**RE: 110 Woodbury Road, Watertown, Connecticut (the "Property")  
Petition for Waiver Pursuant to Ordinance 36-4(e)**

# STUDENT DORMITORY PROJECT THE TAFT SCHOOL

Project:  
**PROPOSED TRACTOR SUPPLY**  
 0 HILLSIDE AVENUE  
 WATERTOWN, CONNECTICUT  
 M/B/L: 124/180/1A

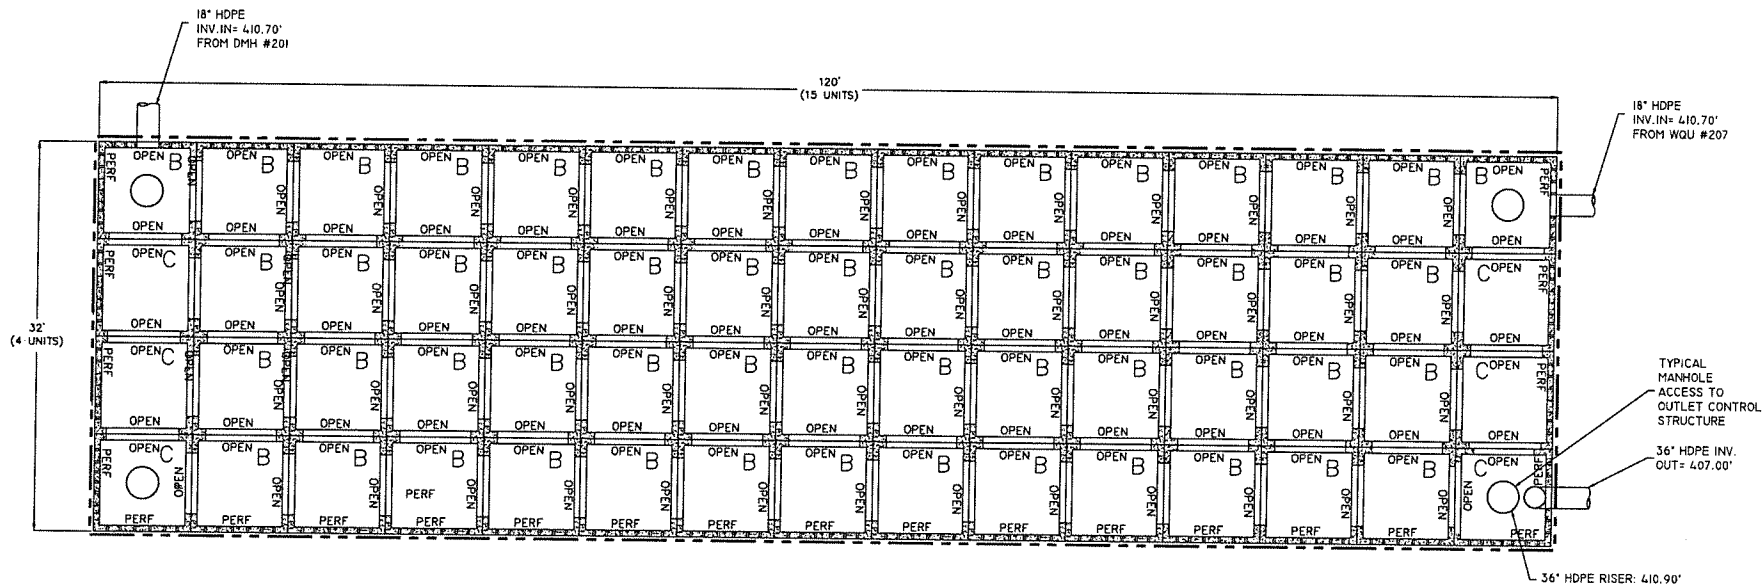
- e) The Stormwater System Detail on Sheet 2.22 should show the extent of the stone surrounding the units.
